UNTIL SUCH TIME AS THESE DRAWINGS ARE APPROVED BY THE AGENCIES, OR ENGINEERING APPROVES THEIR USE, THESE DRAWINGS ARE DESIGNATED BY WRITTEN AUTHORIZATION.	
PREPARED FOR	SR LAND, LLC 20 BOULDER CRESCENT SUITE 201 COLORADO SPRINGS, CO 80903 JAMES F. MORLEY (719) 471-1742
J.R. ENGINEERING A Western Company Central 303-740-9888 • Colorado Springs 719-583-2583 Fort Collins 970-491-9888 • www.jrengineering.com	
BY	DATE
REVISION	
No.	
1"=50'	N/A
H-SCALE	DATE
V-SCALE	09/10/21
DESIGNED BY	AAM
DRAWN BY	CJD
CHECKED BY	
STERLING RANCH PHASE 2 PRELIMINARY GRADING PLAN	
SHEET 6 OF 17	
JOB NO. 25188.02

STERLING RANCH PHASE 2
PRELIMINARY GRADING PLAN

V1_Grading Plan.pdf Markup Summary

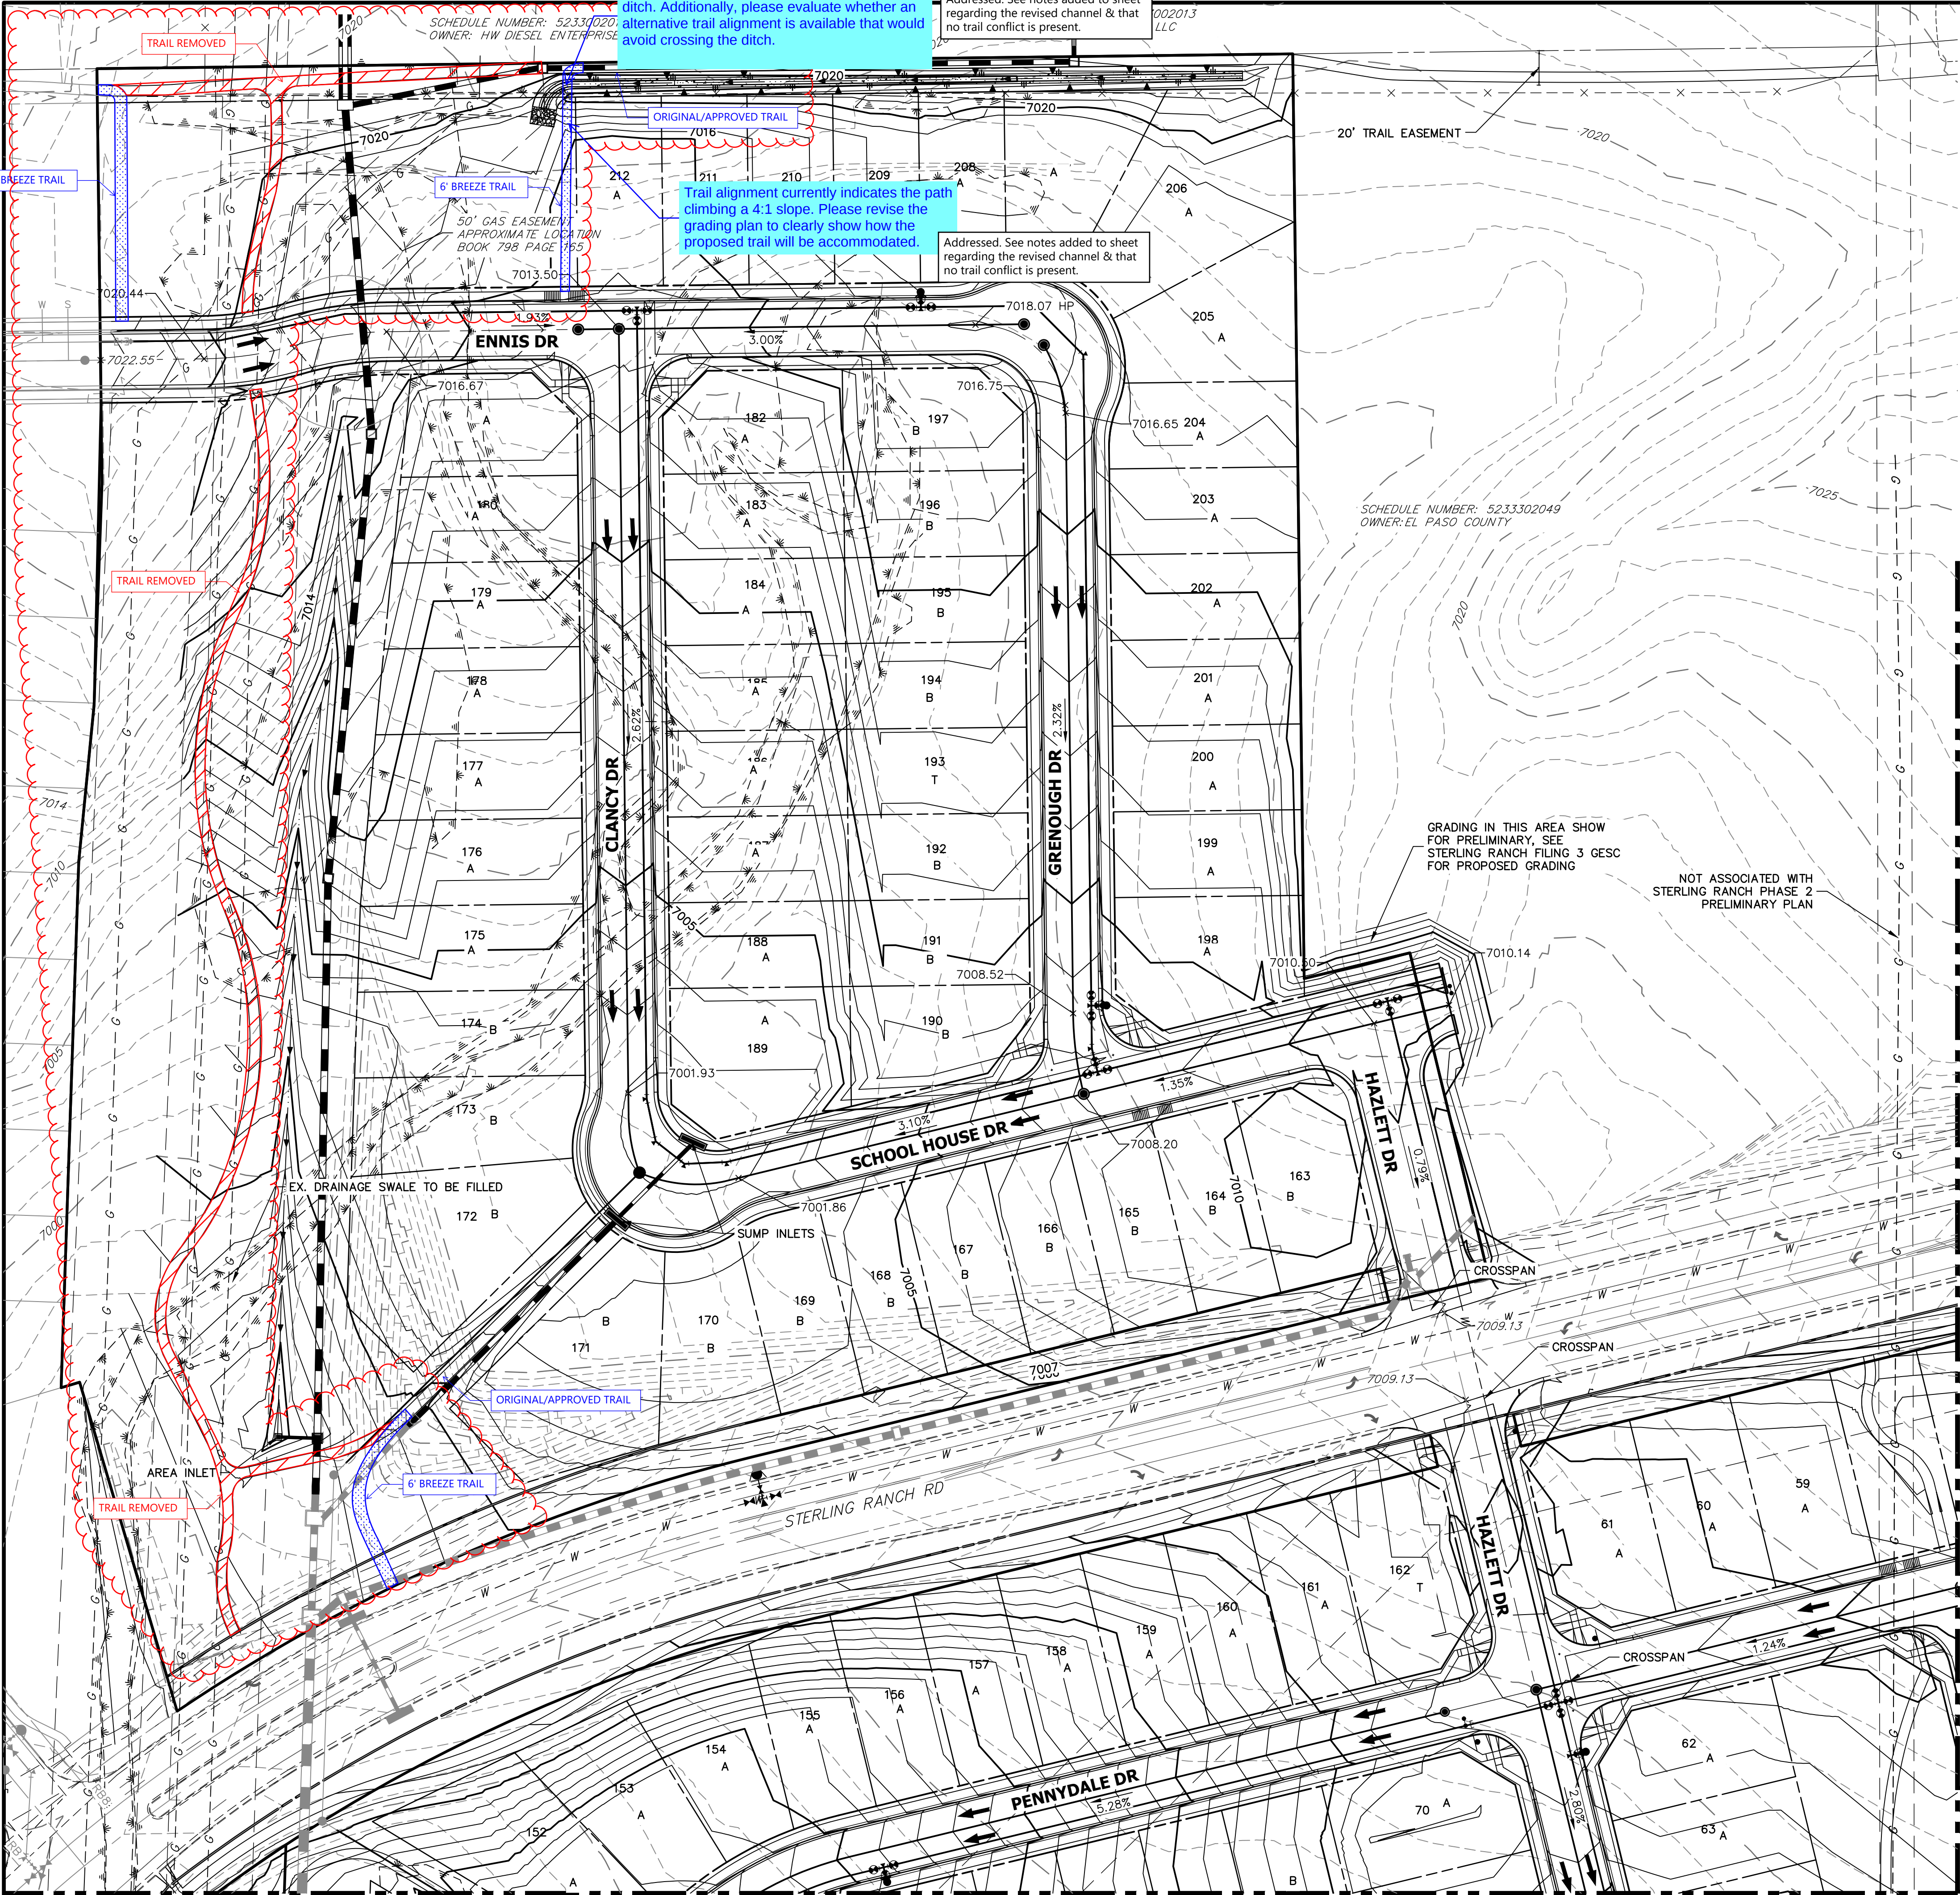
Subject: Callout Page Label: [1] 6 Preliminary Grading Plan - preliminary grading plan - 1 Author: Laura Besler Date: 7/22/2026 8:49:24 AM Status: Color: Layer: Space:	Please provide details demonstrating how the 6-foot breeze trail will cross the FSD overflow ditch. Additionally, please evaluate whether an alternative trail alignment is available that would avoid crossing the ditch.
	Subject: Callout Page Label: [1] 6 Preliminary Grading Plan - preliminary grading plan - 1 Author: Laura Besler Date: 7/22/2026 8:40:57 AM Status: Color: Layer: Space:	Trail alignment currently indicates the path climbing a 4:1 slope. Please revise the grading plan to clearly show how the proposed trail will be accommodated.

SHEET 7 OF 17
JOB NO. 25188.02

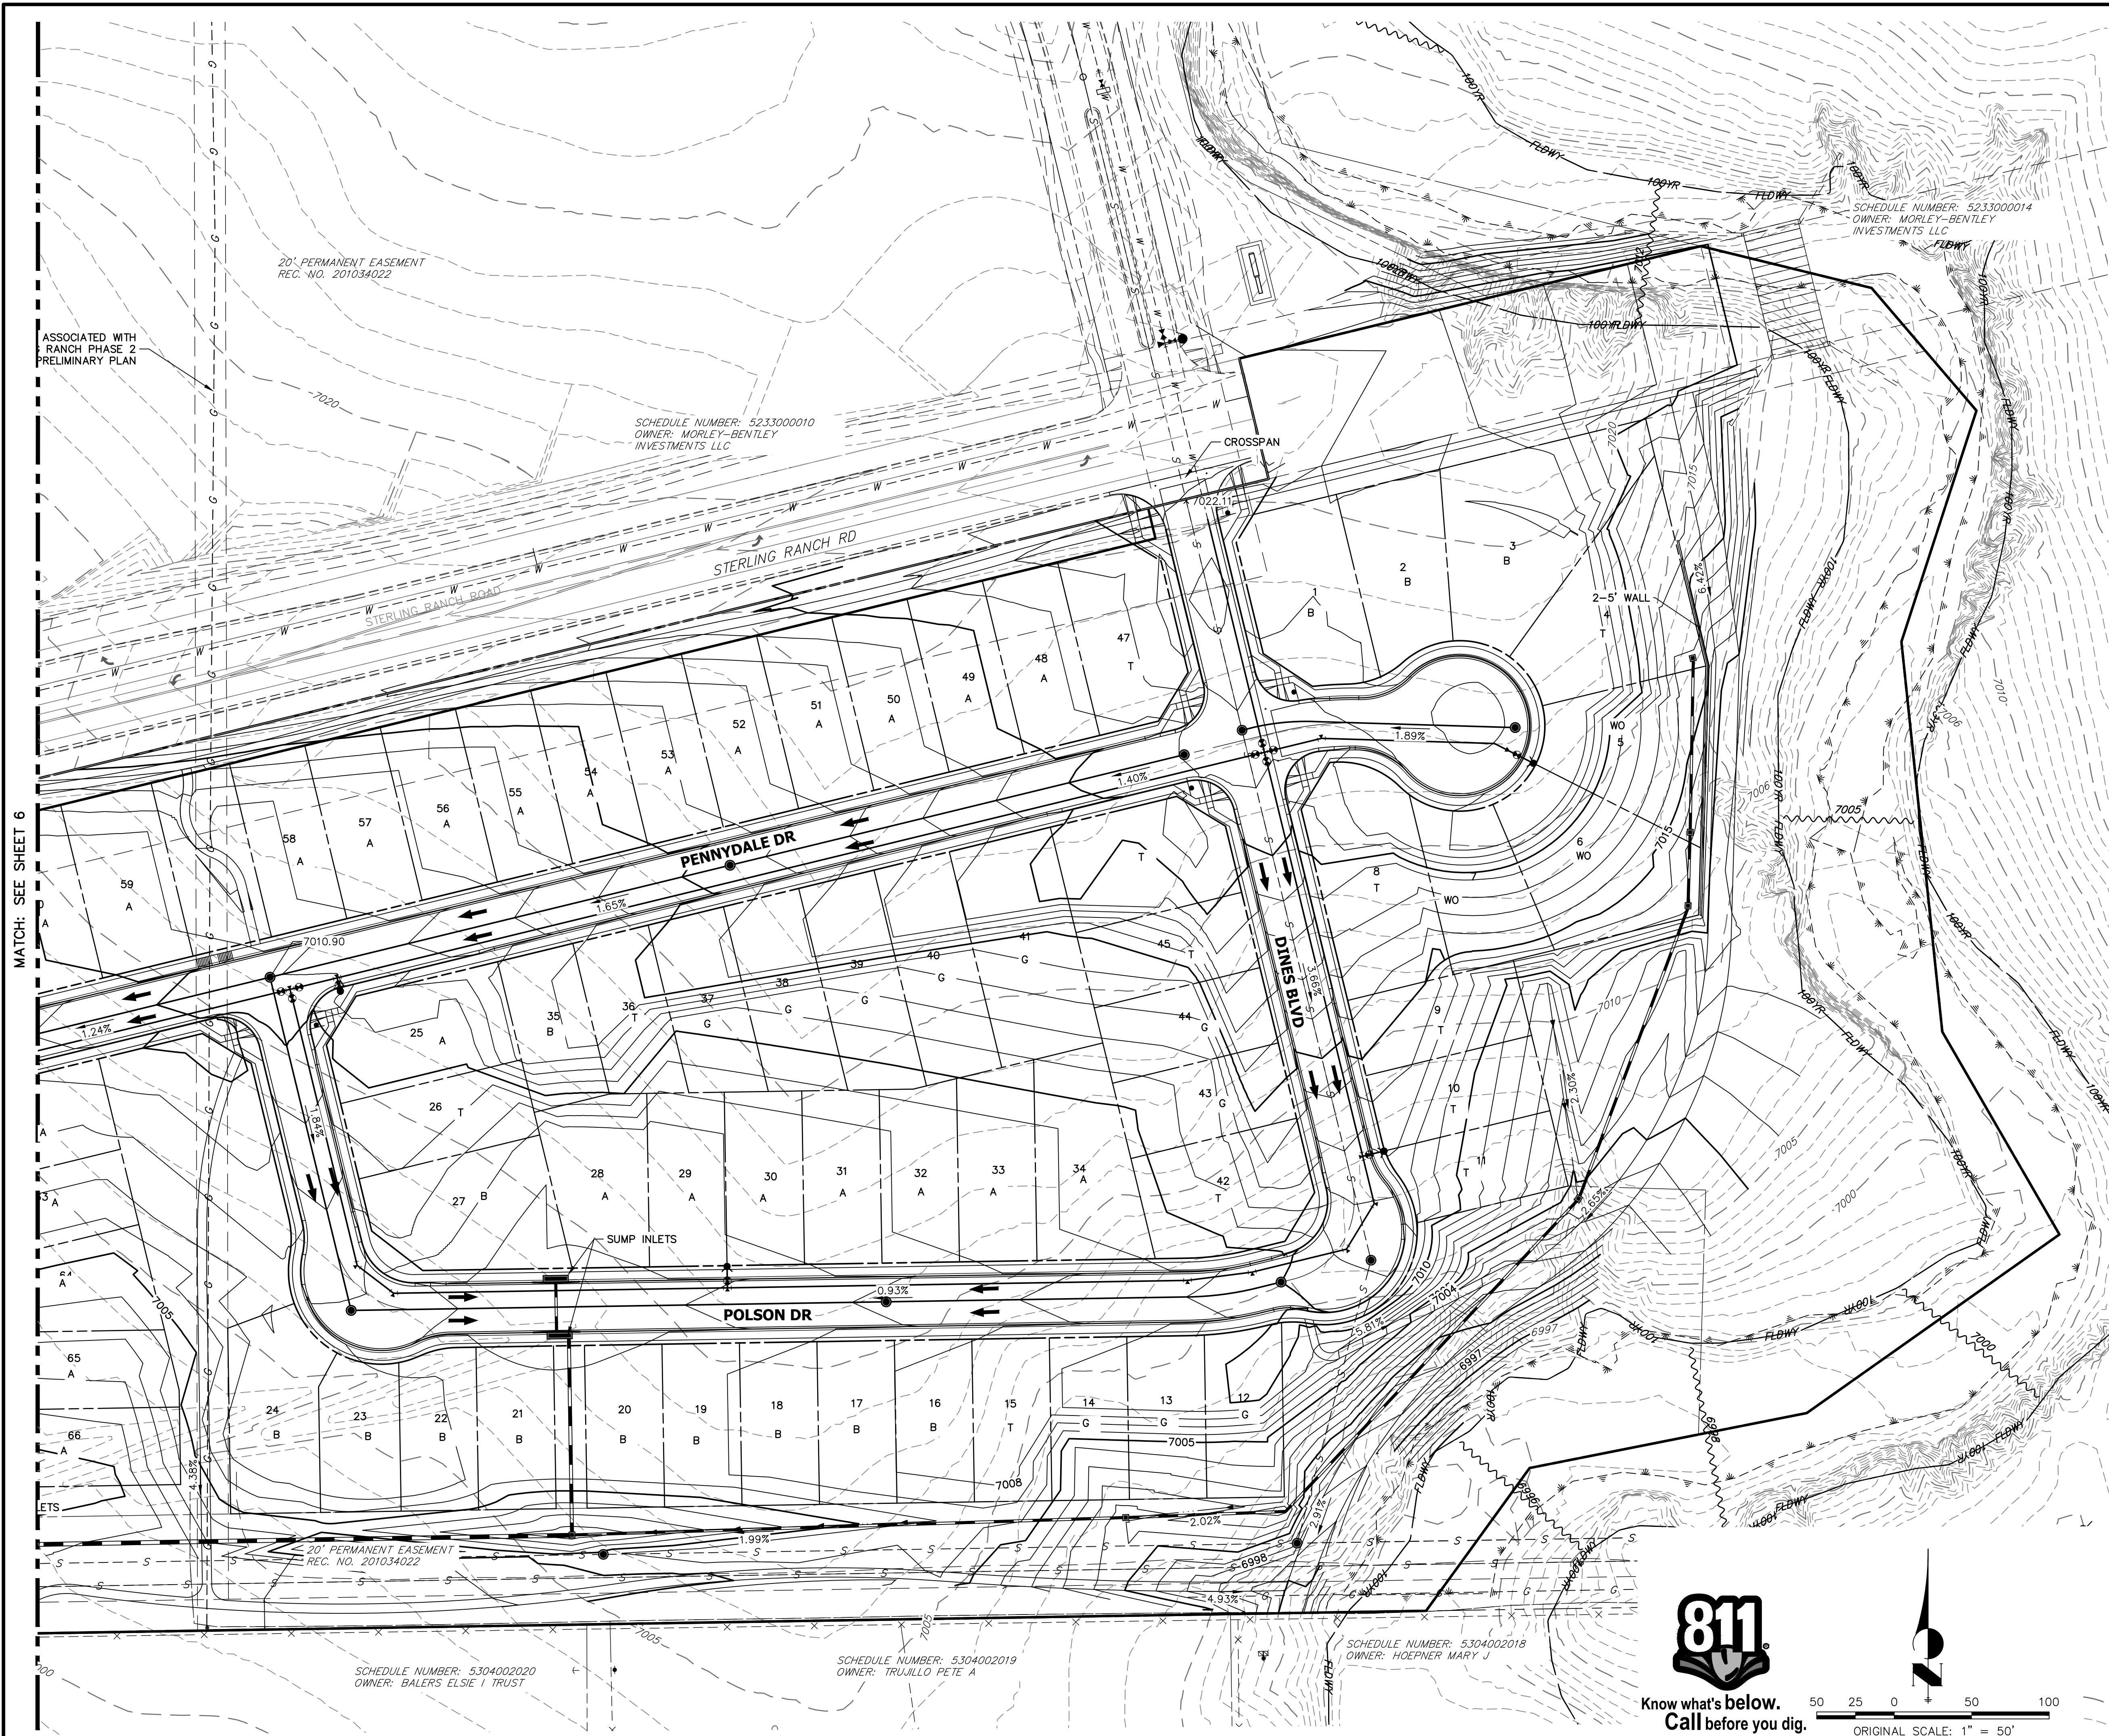
MATCH: SEE SHEET 9

show trail revisions on
this sheet that are
shown on the next sheet

Not addressed. Sheet 9 is located south of here. Sheet reference is correct.
